April 9, 2016

03124 Version 3

Warranty Extension: 2008–10 Accord SRS UnitSupersedes 16-007, dated January 23, 2016 to revise the information highlighted in **yellow****AFFECTED VEHICLES**

REVISED IMAGE

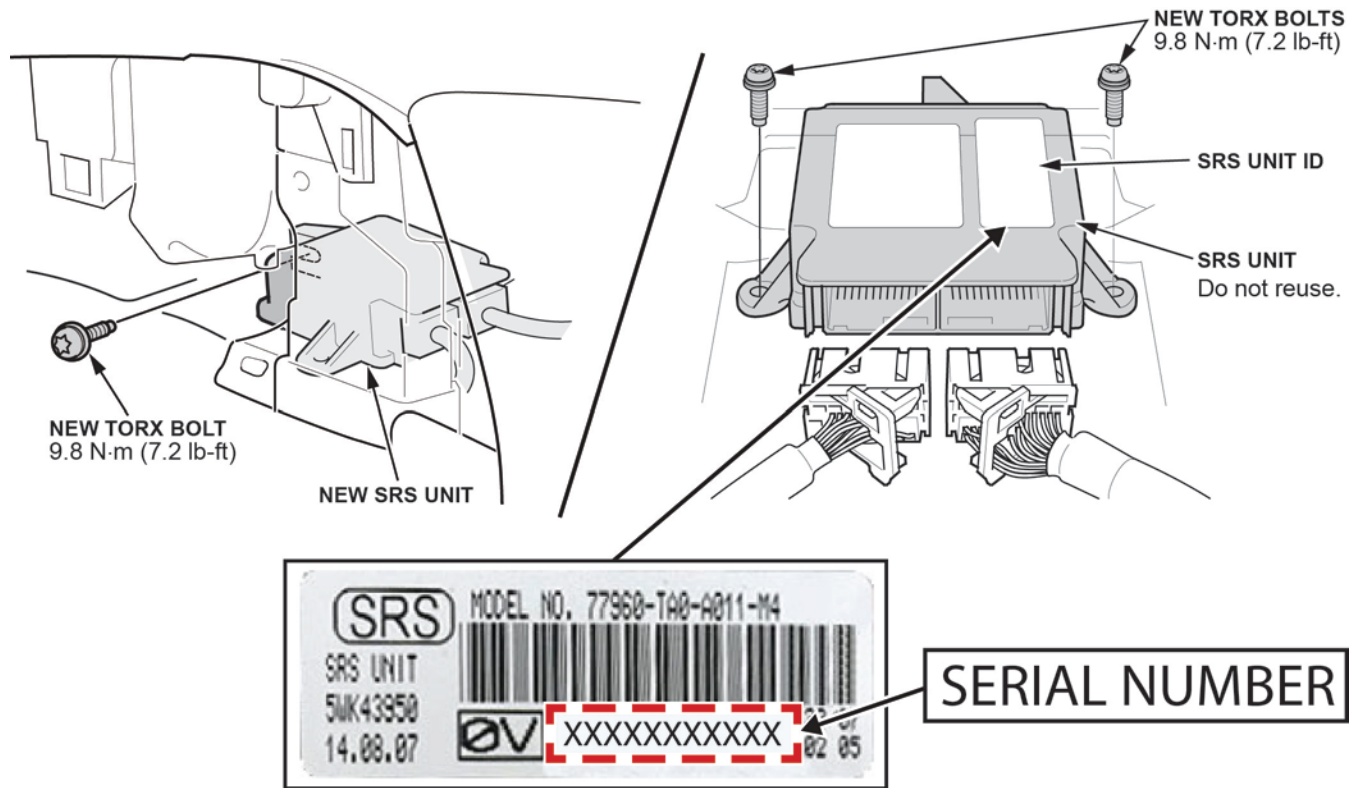
An image was added to show the location of the serial number in REPAIR PROCEDURE. A step was also added to make sure the new serial number was recorded and submitted in the warranty claim.

7. Write down the new SRS unit ID (serial number) on the RO, then install the new SRS unit using the new Torx bolts.
